# Proposed Amendments to the Seton Ridge DA

Case 22896

June 10, 2021

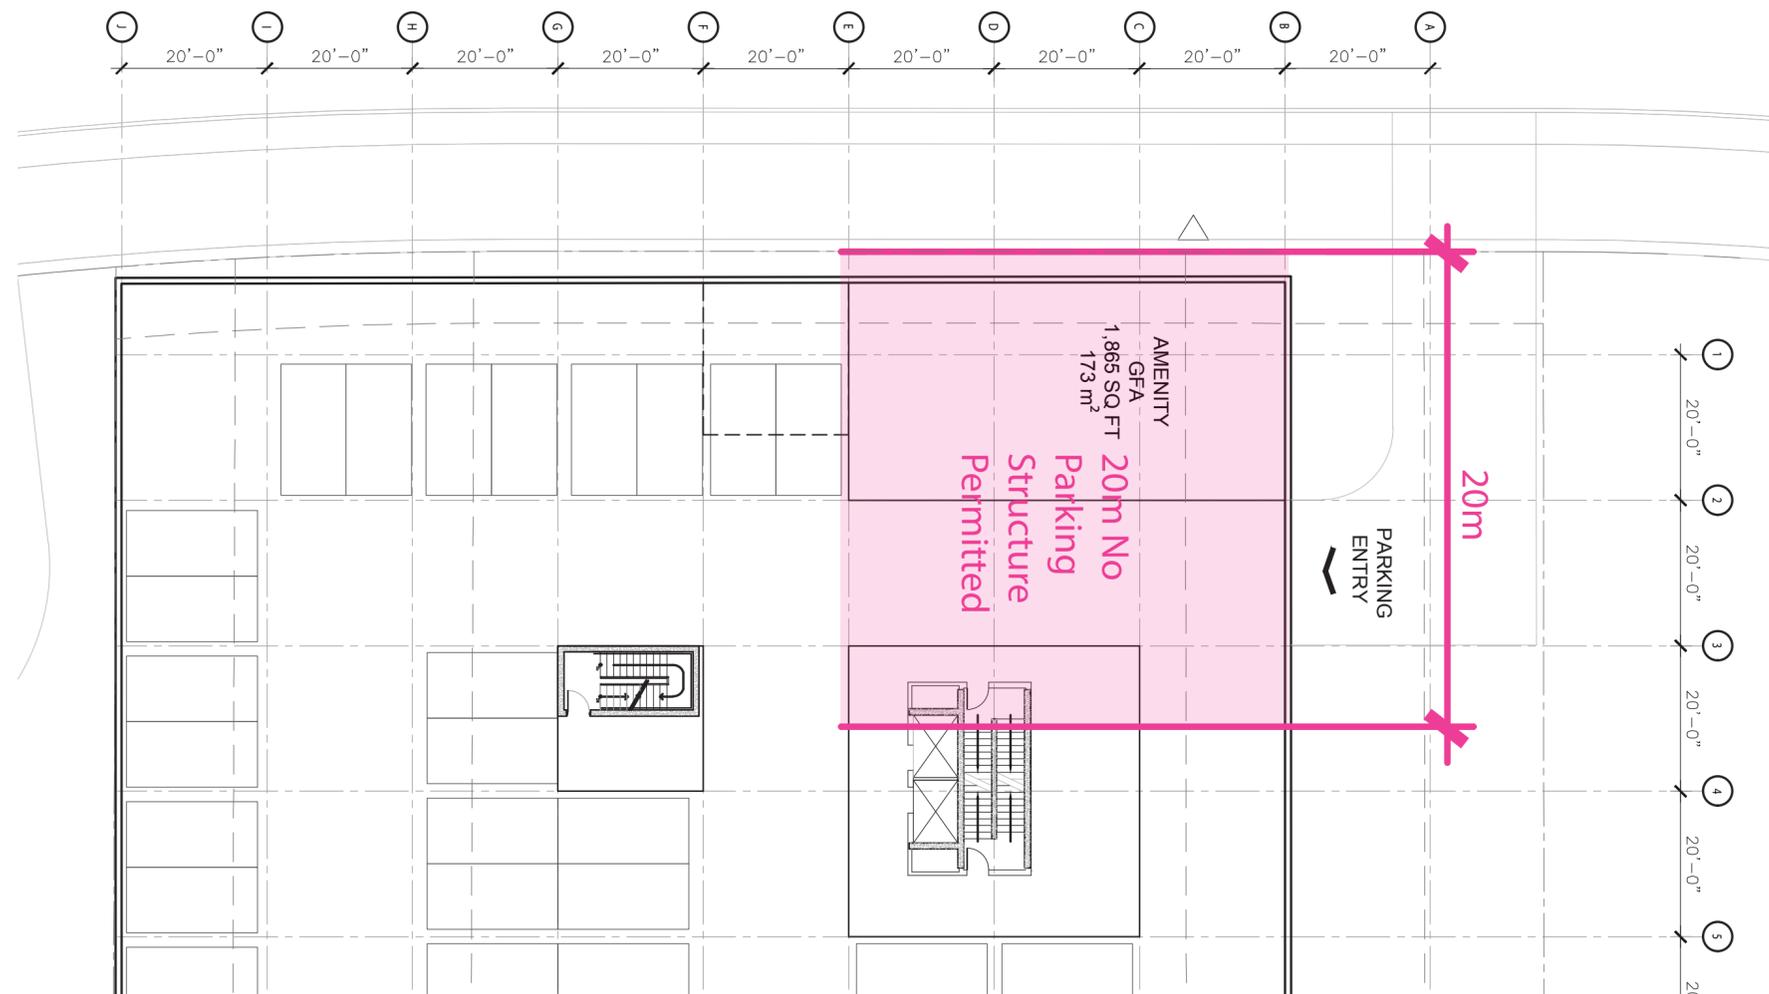
# Rooftop Exemptions Table

**Table 4: Features exempt from maximum height requirements**

# Schedule C5

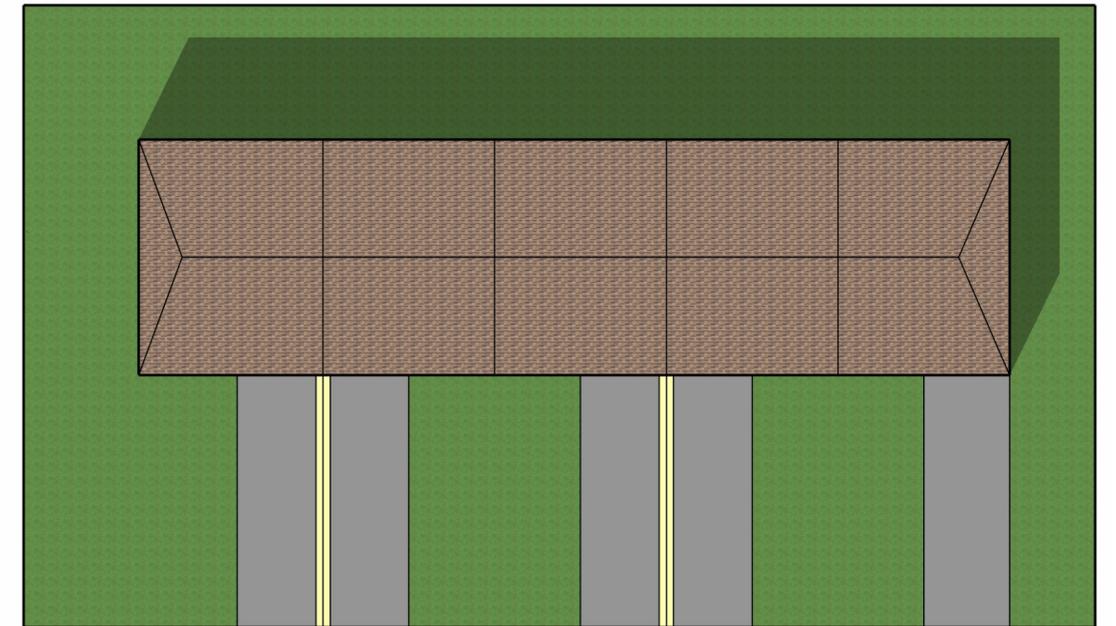
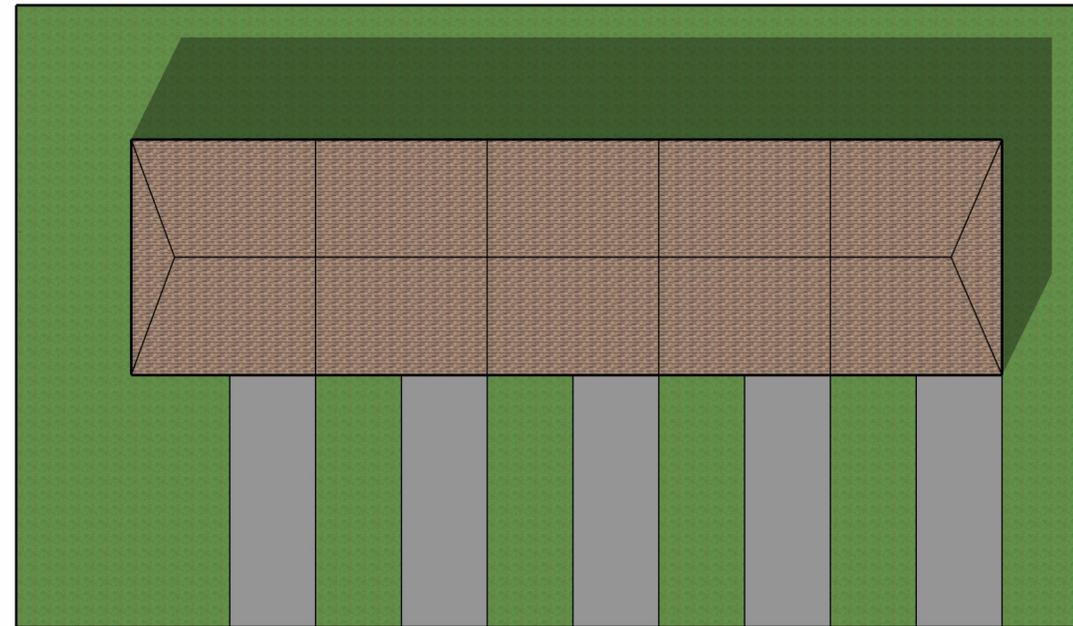
15. For Townhomes, where possible, driveways shall be paired with a decorative strip between driveways that are a minimum of 30 cm (1 foot) in width to a maximum width of 1.5 metres (4.92 feet).

16. The Development Officer may waive the requirement to pair townhouse driveways if design constraints limit the feasibility of pairing driveways including, but not limited to, the placement of services and utilities, grade changes, the curvature of the road or an uneven number of dwellings.

# Schedule C5

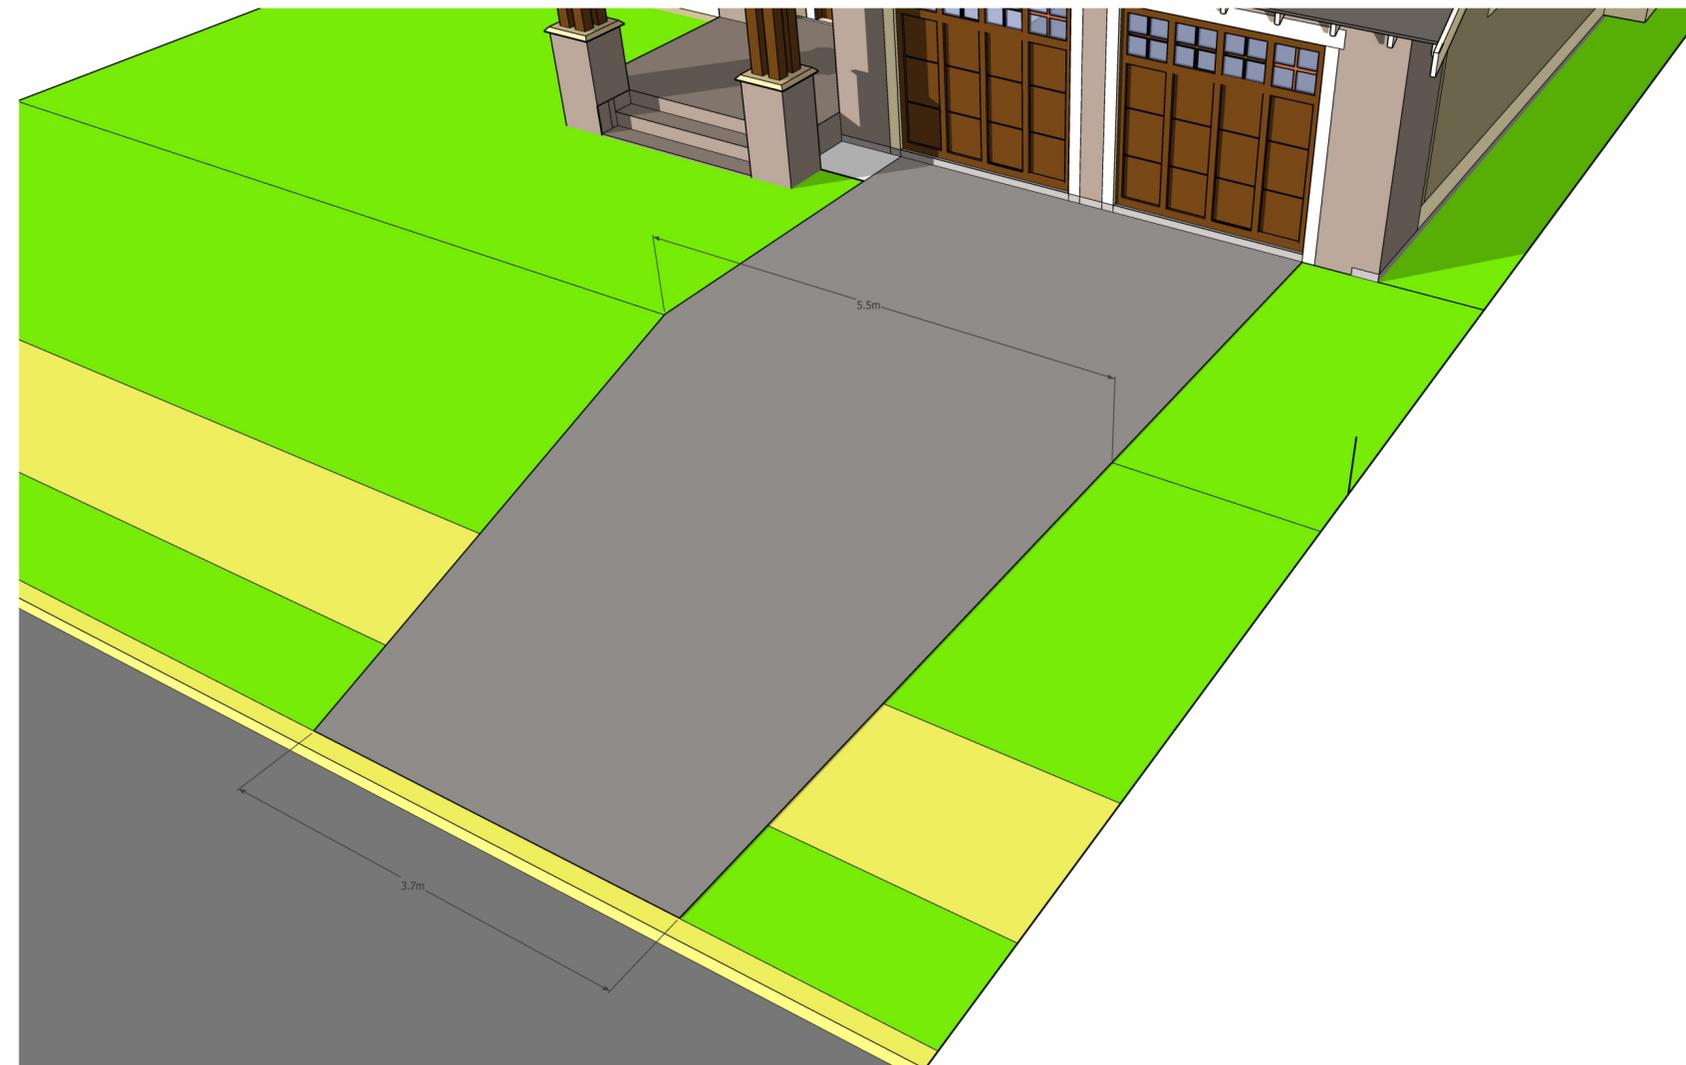
17. The maximum width of any driveway between the curb and front property line shall be 3.66 metres (12 feet) per dwelling, and shall not exceed 4.27 metres (14 feet) in width in the front yard.

17. The maximum width of any driveway at the curb shall be 3.66 metres (12 feet) per dwelling, and shall not exceed 5.5 metres (18 feet) in width in the front yard.

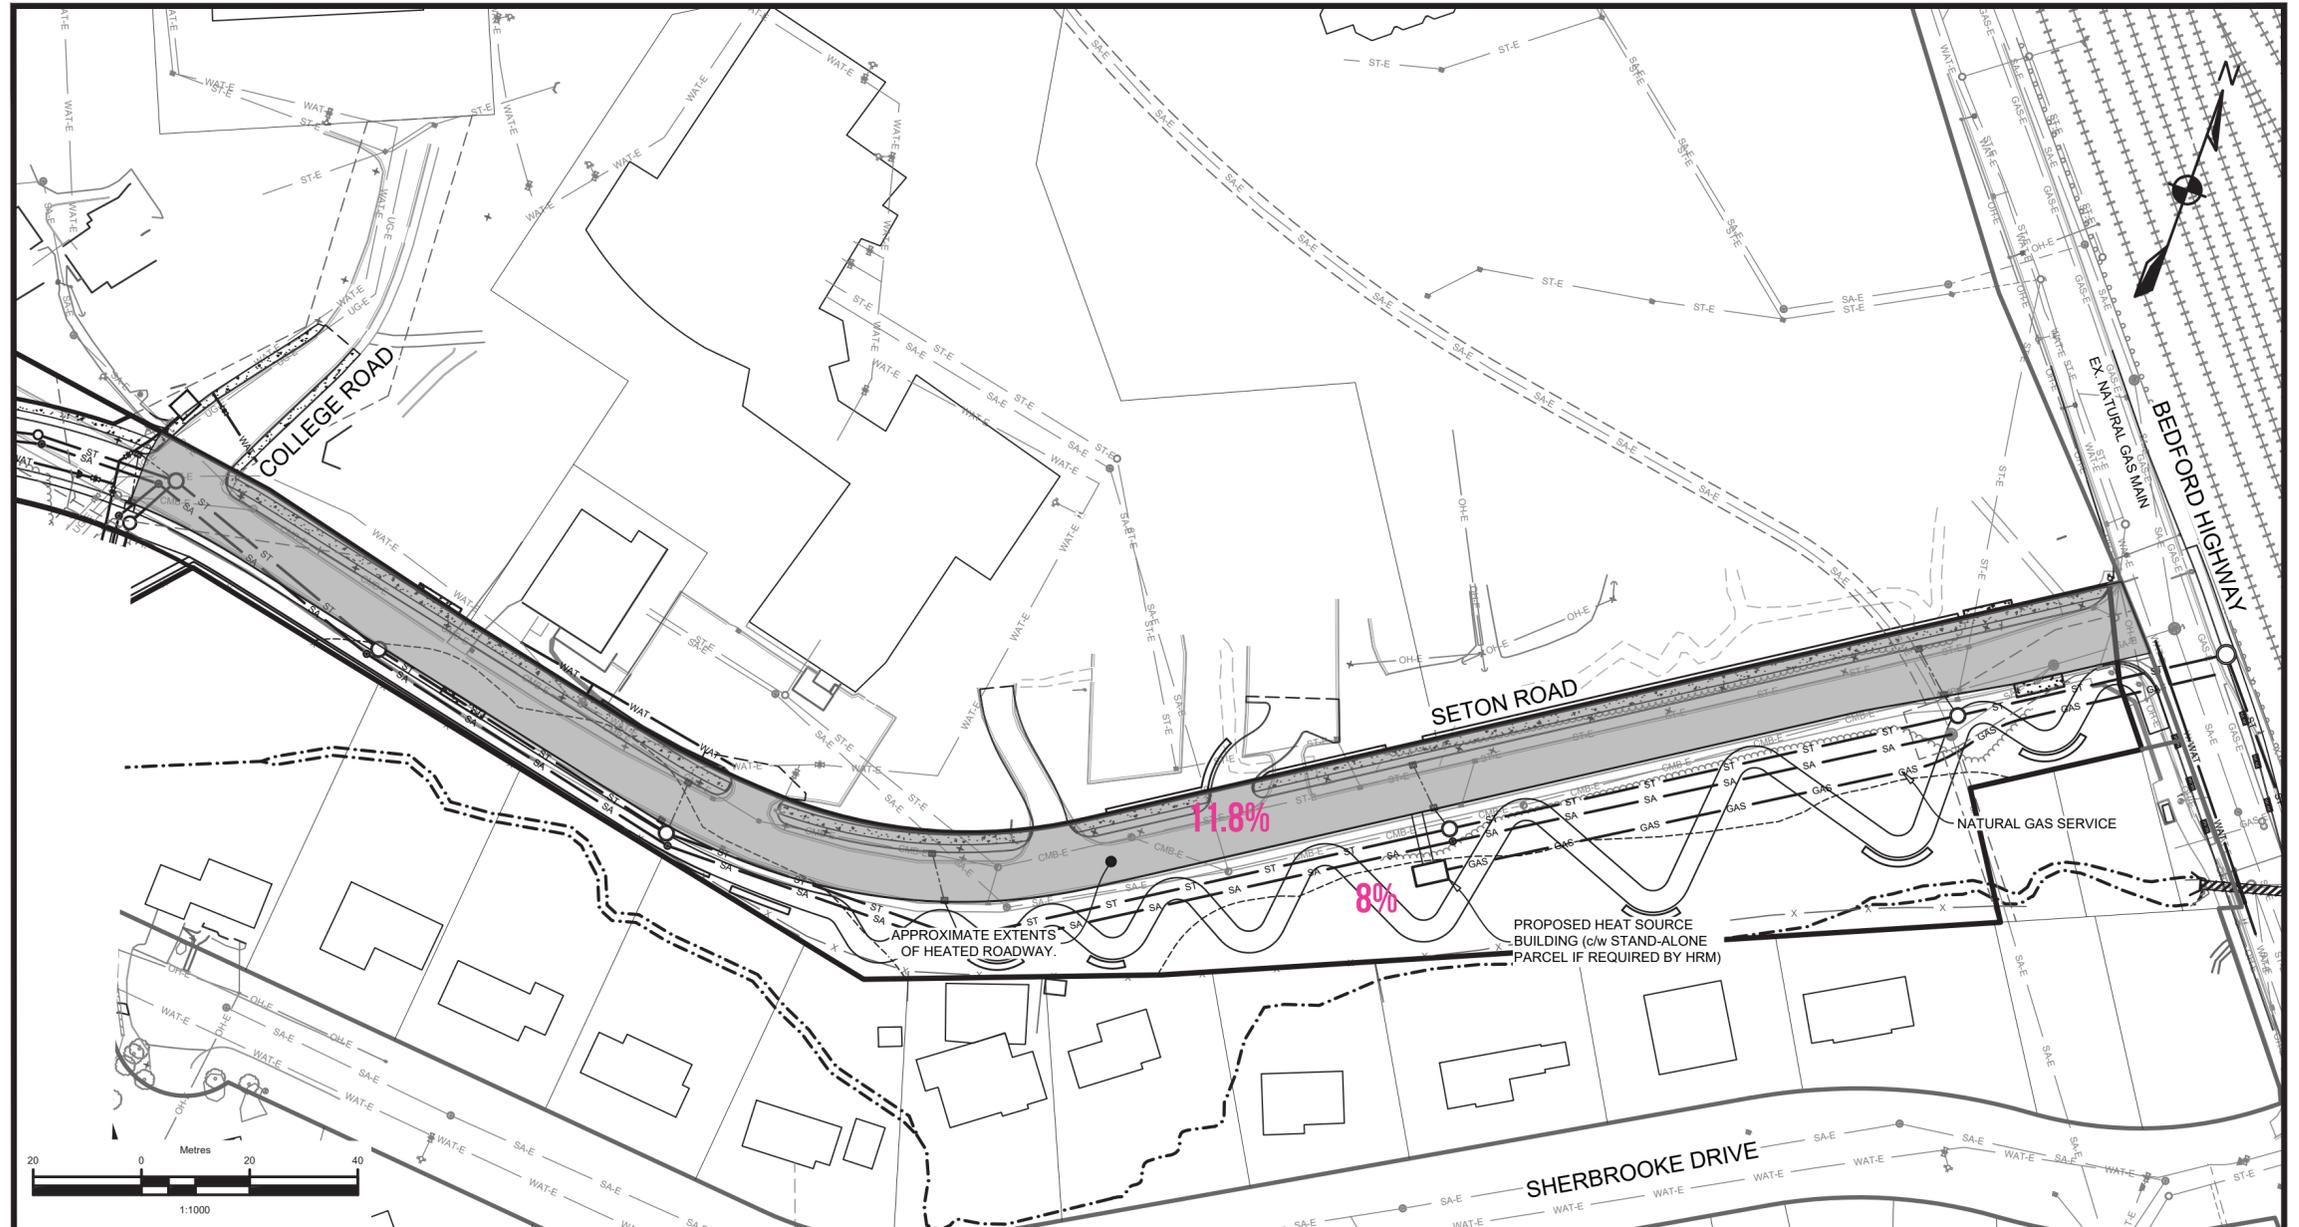
2. The Developer agrees to construct an Active Transportation (AT) pathway alongside the collector road, within the general area shown on Schedule C2, that includes a curvilinear design with rest and transition areas to reduce the overall grade of the pathway.

It was always our understanding that the 'curvilinear design' reference in the DA was added in an attempt to reduce the overall grade of the trail where possible compared to Seton Road; with the understanding that since the road right-of-way width is constrained, there are real practical limitations to the degree of curvilinear-ness that could be accommodated to reduce the trail slope. To meet an 8% slope limit, the AT trail would have to be 1.4x the length of the Seton Road and we simply do not have the room in the future and existing right-of-way to accommodate this length.

2. The Developer agrees to construct an Active Transportation (AT) pathway alongside the collector road, within the general area shown on Schedule C2, that includes a curvilinear design with rest and transition areas to reduce the overall grade of the AT pathway as much as may be practical from the adjacent road slope.
